**From:** Sgarro, Rocco R [rrsgarro@pplweb.com]  
**Sent:** Saturday, September 26, 2009 7:49 AM  
**To:** Imboden, Stacey; 'Bruce.Mcdowell@pnl.gov'  
**Cc:** 'Lutchenkov, Dimitri'; 'Perdomo, Federico R'; 'Beecher, Kimberly A'; Fields, Jerome S; Woodring, Kathryn L; Harpster, Terry L  
**Subject:** RAI responses  
**Attachments:** BNP-2009-282 - 5th ER RAI Response Letter with all Enclosures.pdf

**BELL BEND NUCLEAR POWER PLANT  
RESPONSE TO ENVIRONMENTAL  
REQUESTS FOR ADDITIONAL  
INFORMATION, FIFTH SUBMITTAL  
BNP-2009-282      Docket No. 52-039**

RAI H 5.2-1 Calculation  
Low Flow Recurrence Interval and Low Flow Statistics (BBNPP) (Rev. 2)  
September 18, 2009  
Bell Bend Nuclear Power Plant  
Luzerne County Pennsylvania

Figure 1

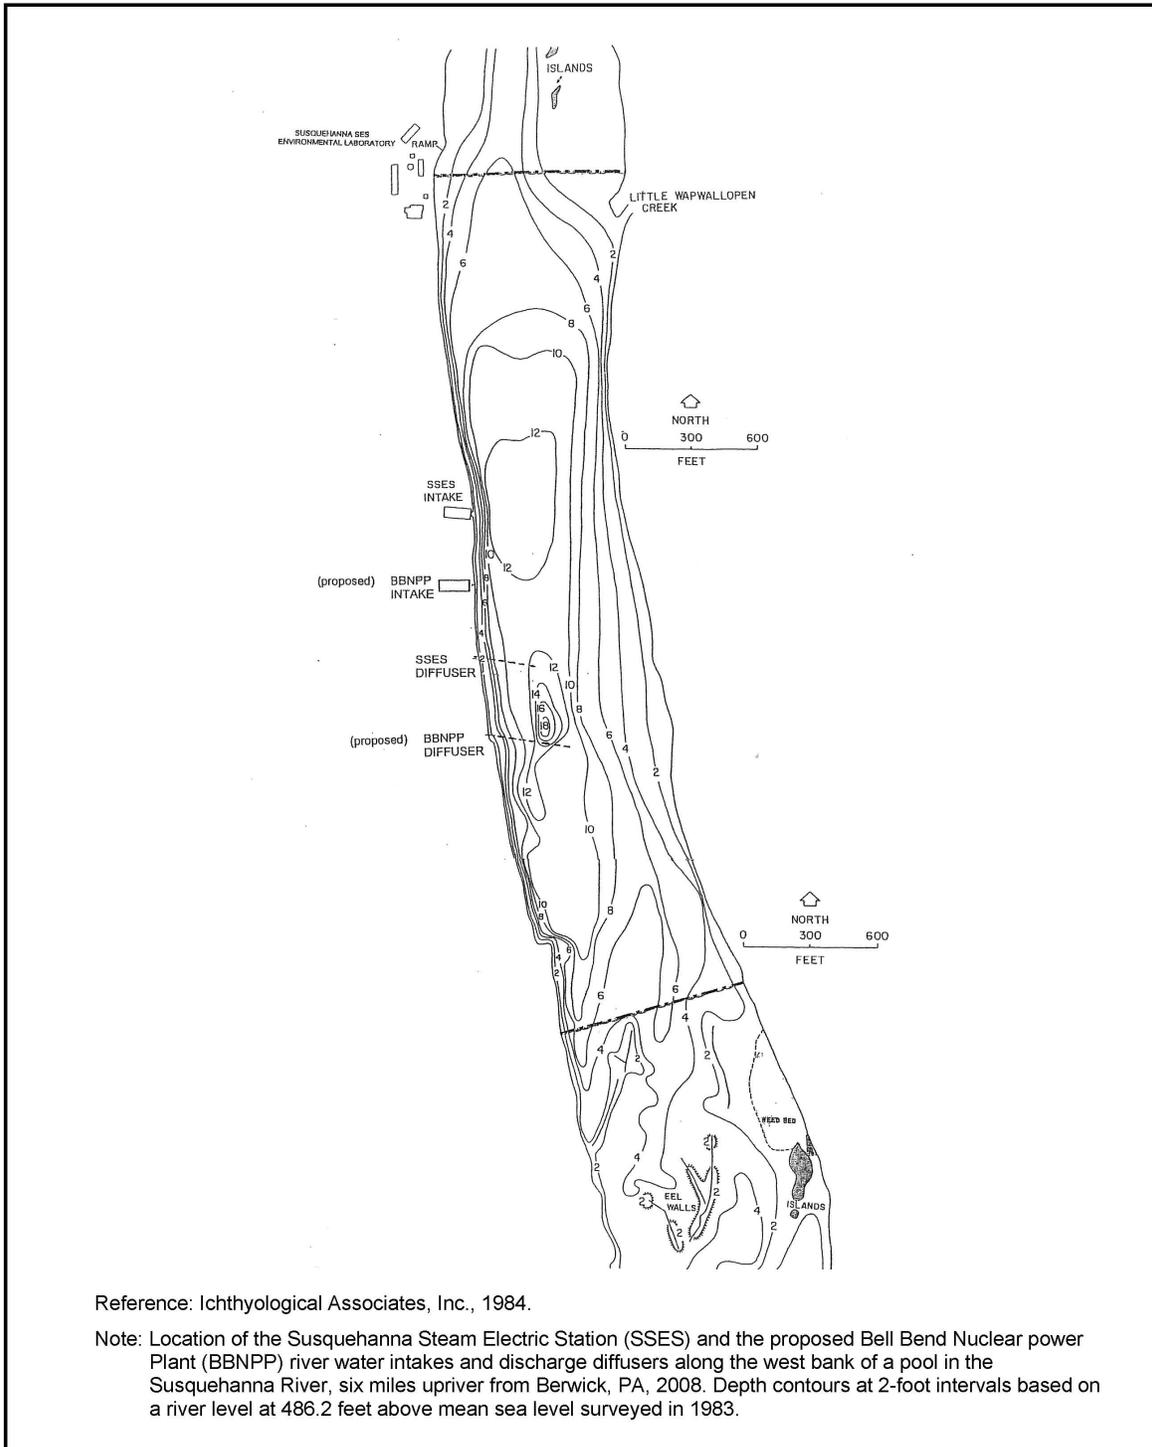
**Summary:** *Provide correct water depth (as feet below a standard reference point) at the intake and discharge areas in the Susquehanna River.*

**Full Text:** The bathymetry of the Susquehanna River is provided as feet above mean sea level. The text indicates that the riverbed elevations near the intake range from 473 to 484 ft. Figure 2.3-11 shows the contour range at the intake site to be from 476 to 490 ft. The 473 ft contour is a small area about 200 ft south of the proposed intake site. The depth of the discharge listed in Ch. 3 differs from that in Ch. 2.

**Response:** Ichthyological Associates' report provides a figure (Figure 1) showing the depth contours in the vicinity of the intake and discharges structures. Depth contours are based on a river level at 486.2 ft above mean sea level (msl) surveyed in 1983. Figure 1 follows.

FIGURE 1-1  
LANDFILLS IN PA WITH CAPACITY FOR 3.5 MILLION CUBIC YARDS

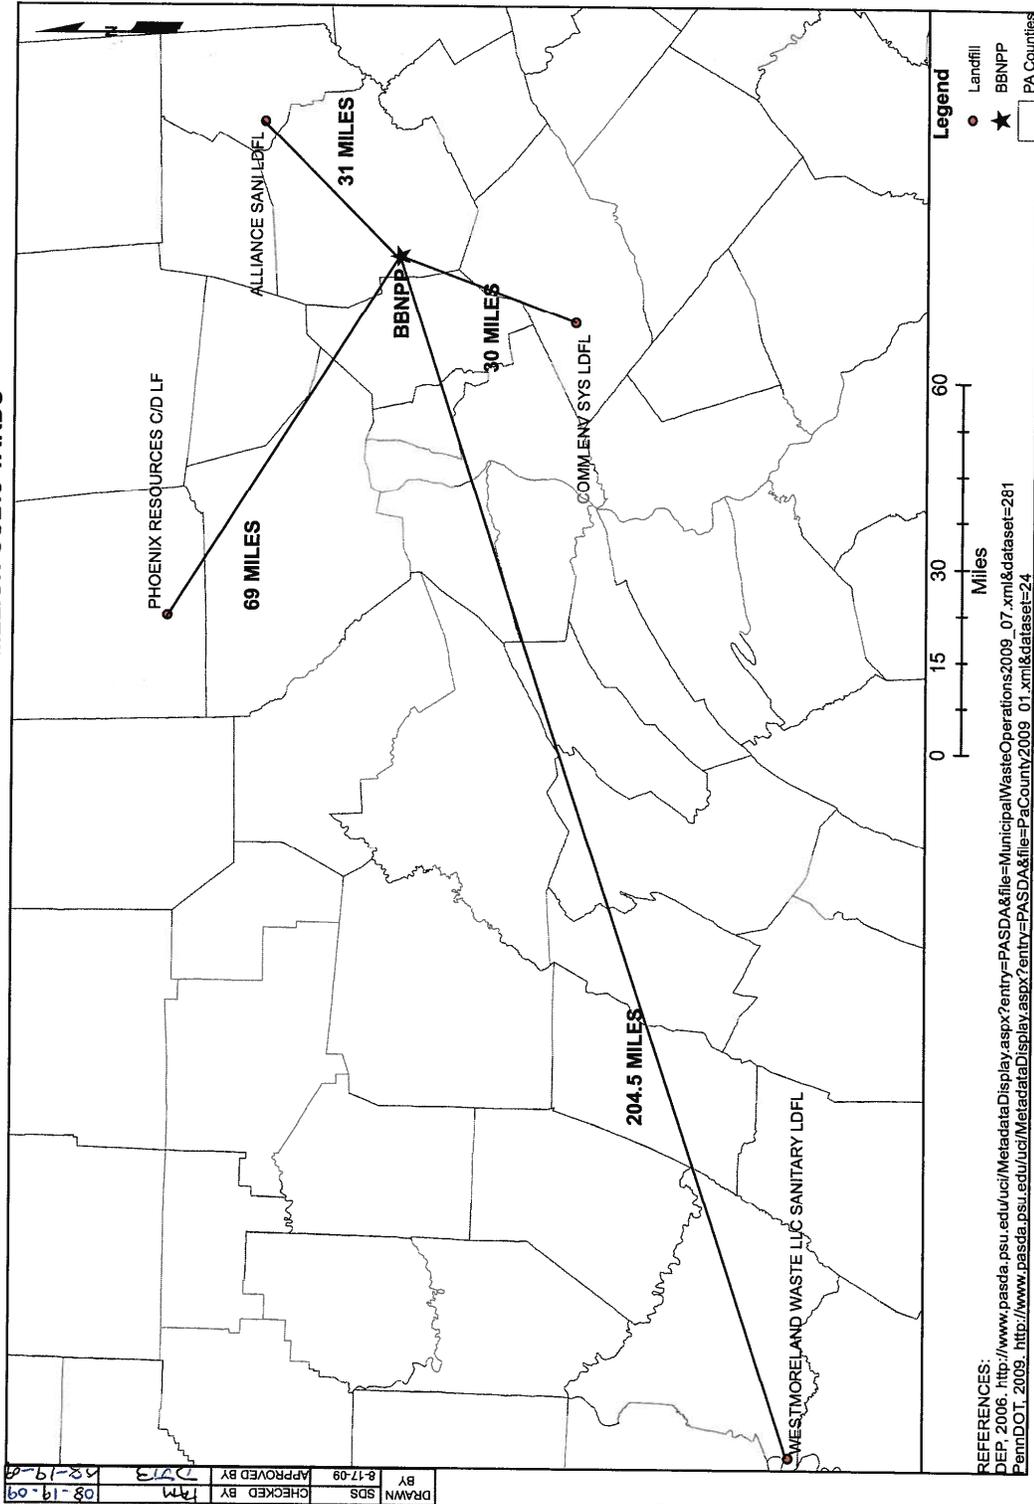
**Summary:** *Provide the location of the disposal site for excess excavated material (soils), the planned routes for transporting the excess material and any upgrades necessary for these routes, and any planned measures for erosion control and stabilization of the disposal site at project completion.*

**Response:** Location: Figure 1-1 is attached which shows four existing solid waste disposal areas, each of which can take over 3.5 million cubic yards of waste material. The landfills shown are:

Transportation: The landfills shown on Figure 1-1 are existing, and public roads lead to each of the sites. The spoils materials from the site will be transported on existing public roads to the landfill or landfills used. Upgrades or maintenance of the roads to each site would be decided by a state or local agency. The locations and route to each landfill are:

Erosion Control: For a site to be approved it must file an erosion control plan, a soil stabilization plan, a long term care plan, and a closure plan. Each of the sites is existing and open to the public, so each site should have these plans filed and approved.

FIGURE 3.4-3

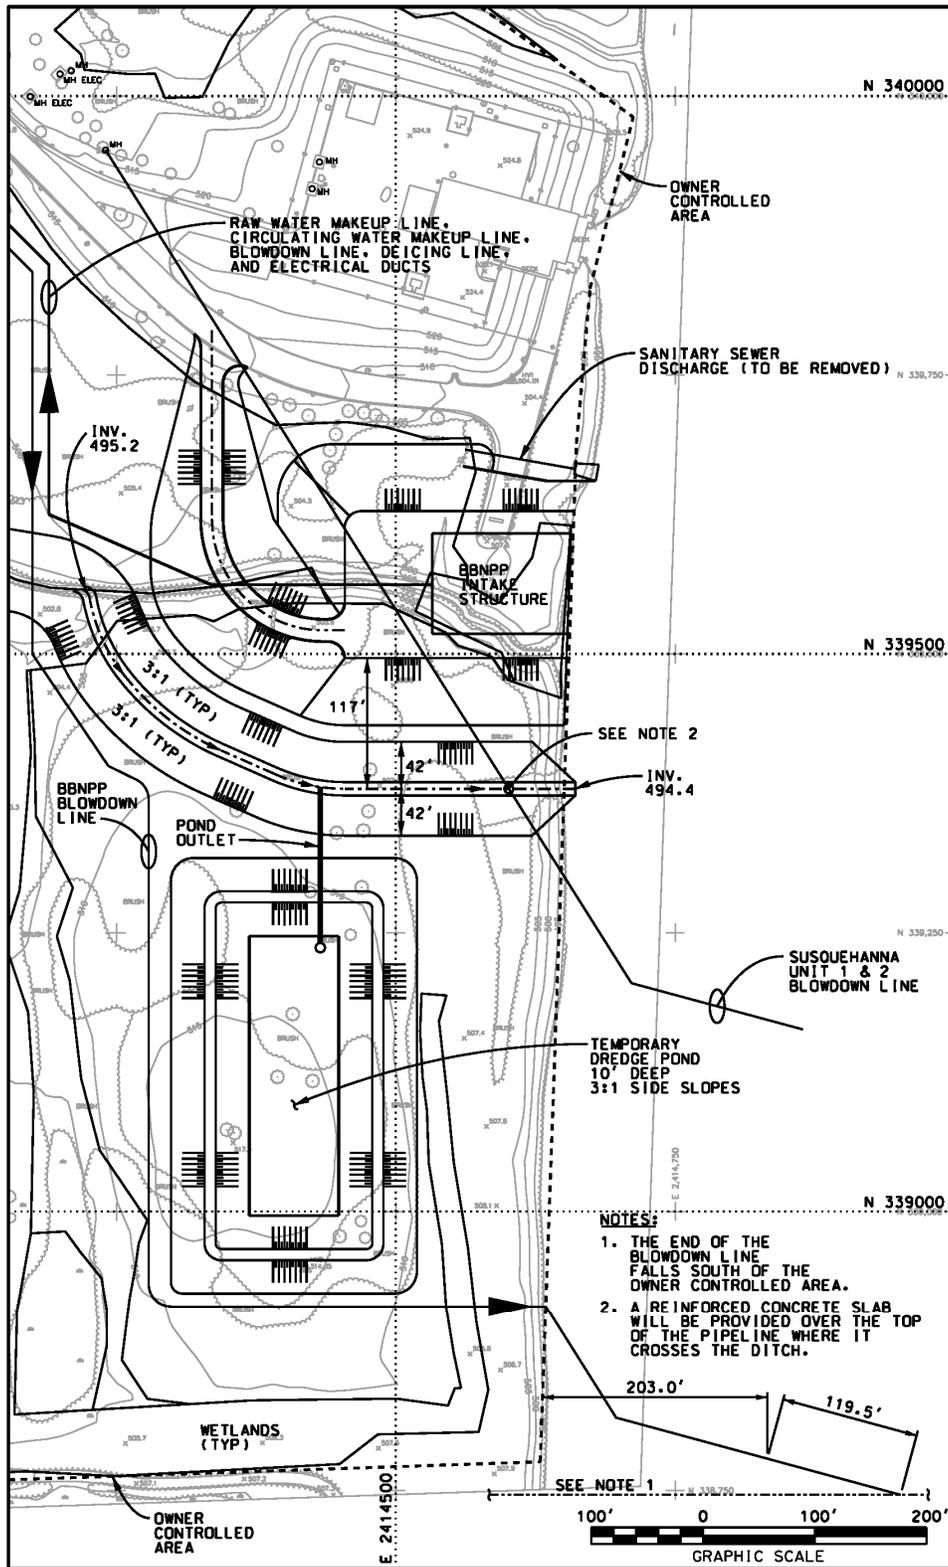
**Summary:** *Provide a figure showing the locations proposed for storage of dredge and fill materials.*

**Response:** Figure 3.4-3 is provided to show a temporary dredge pond. Dredge spoils are pumped into the pond, the spoils settle out, and the excess water drained off and discharged back to the river. The water will meet the requirements of the PaDEP before being released. After the dredging is completed, the entire dredge pond will be removed, and the pond and dredge spoils hauled to a solid waste disposal area. The temporary dredge pond area will be returned back to its original state.

FIGURE 1-1  
LANDFILLS IN PA WITH CAPACITY FOR 3.5 MILLION CUBIC YARDS

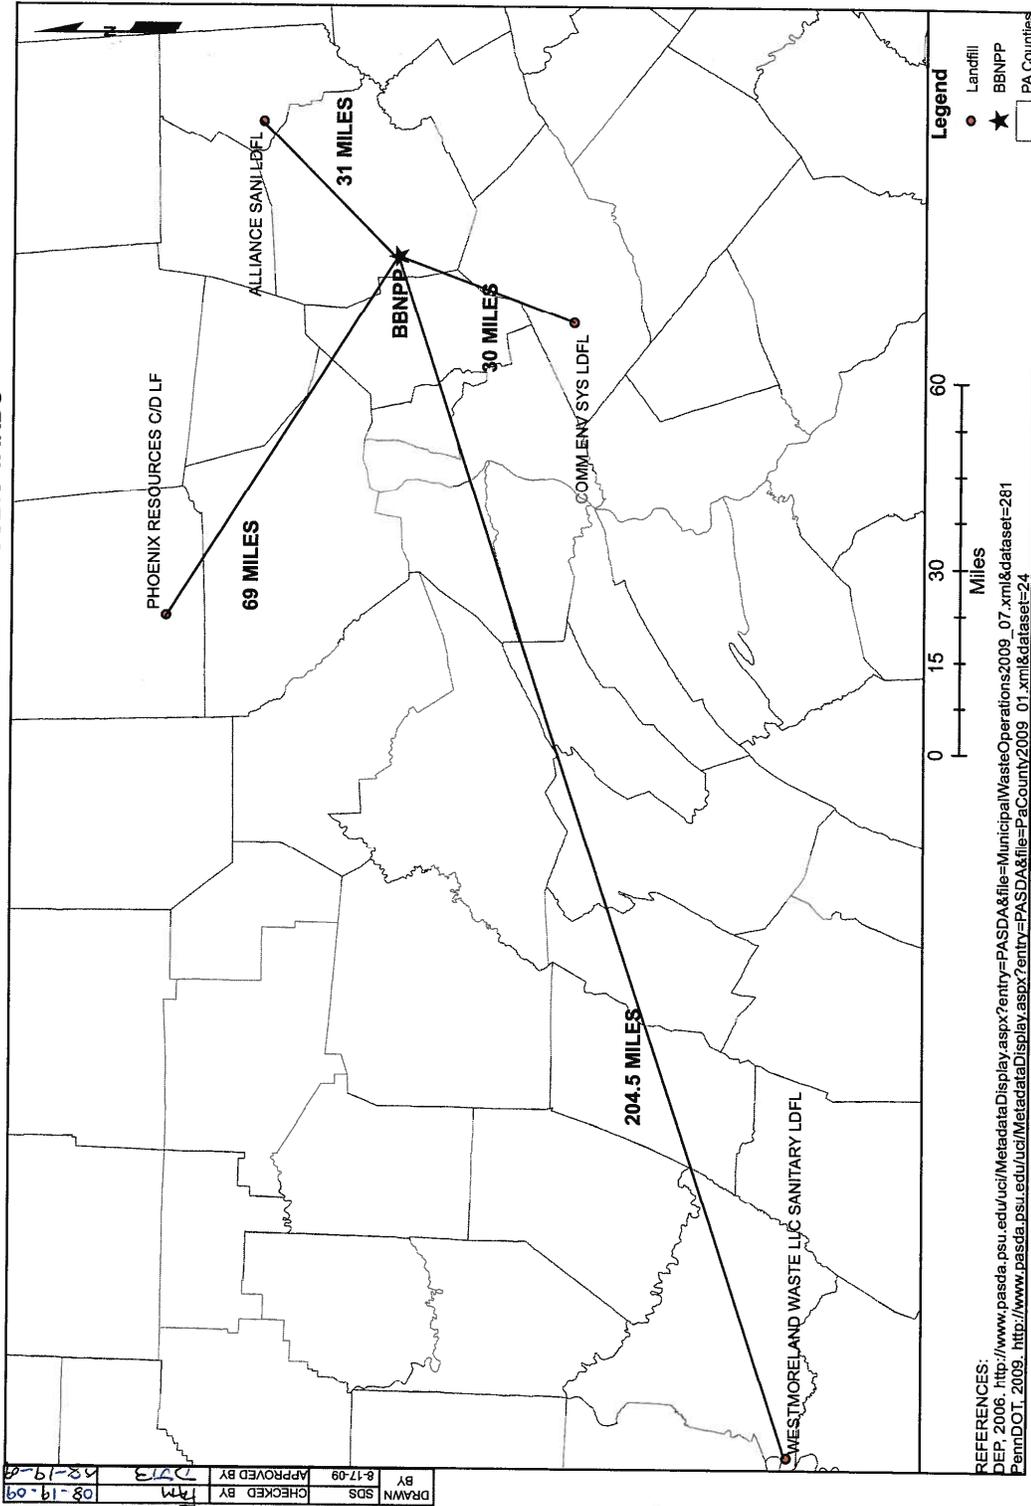
**Summary:** *Provide a vicinity map and plan for the disposal options for any excess fill material resulting from construction.*

**Response:** Location: Figure 1-1 is attached and shows four existing solid waste disposal areas, each of which can take over 3.5 million cubic yards of waste material. The landfills shown are:
